**Dogger Bank South Offshore
Wind Farms**

**Response to RSPB Comments on Digital Aerial
Surveys**

Document Date:	March 2025
Application Reference:	13.4
Revision Number:	01
Classification:	Unrestricted

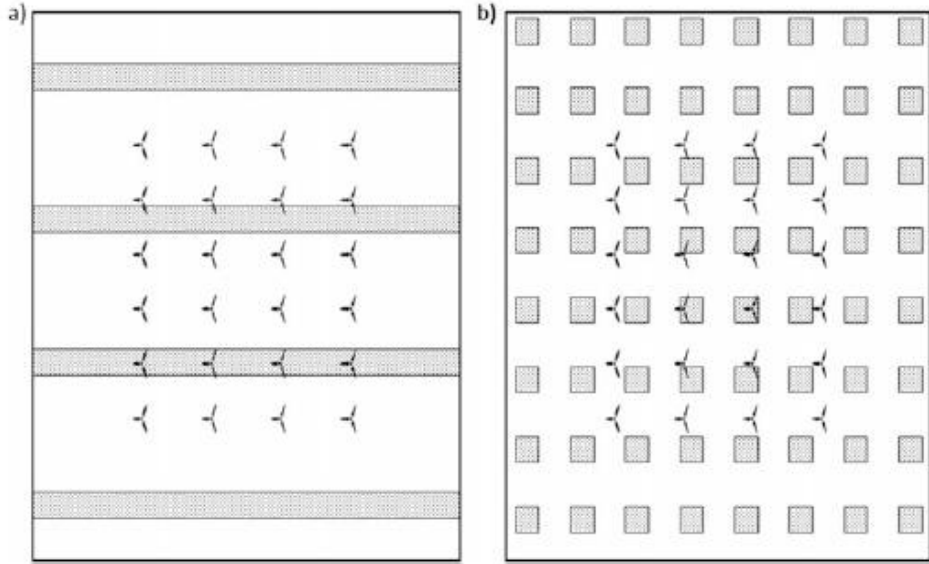
Para. 4.27 - 5	<p>There is no rationale provided as to why a grid rather than transect survey design has been used. Both survey designs are commonly used in the assessment of the impacts of offshore wind farms, and</p>	<p>Whilst transect survey designs have historically been the most widely used method of analysis due to development from visual surveys, APEM investigated the most robust methods to utilise and designed the grid survey based on the traditional quadrat ecological surveys.</p>

RSPB Ref. [RR-049]	RSPB Comment	Applicants' Response
	both have strengths and weaknesses. Detail is required as to why a grid design was used for this assessment.	A grid design was chosen because it samples the survey area systematically and is less prone to missing areas of possible significance. Whereas a transect design can provide high coverage for a lower cost per unit area, it does not sample the area evenly and therefore may miss significant portions of area with important underlying environmental variables. As most transect surveys collect data from few transects, there can be much variation between transects in the numbers of individuals recorded. This reduced sample number will increase the confidence intervals in the population estimate and reduce its precision, making it more difficult to assess changes over time. Due to grid cells normally being separated by a large distance, each individual cell can be considered to be a separate and independent sample. The independence of the cells can be formally tested to ensure that there is no pseudo-replication. Grid designs thus normally have a much greater sample number, reducing variation between images and resulting in a greater confidence in the estimate and a high degree of precision. The differences between (a) a transect design and (b) a grid design on spatial distribution across the survey area is shown in the figure below.
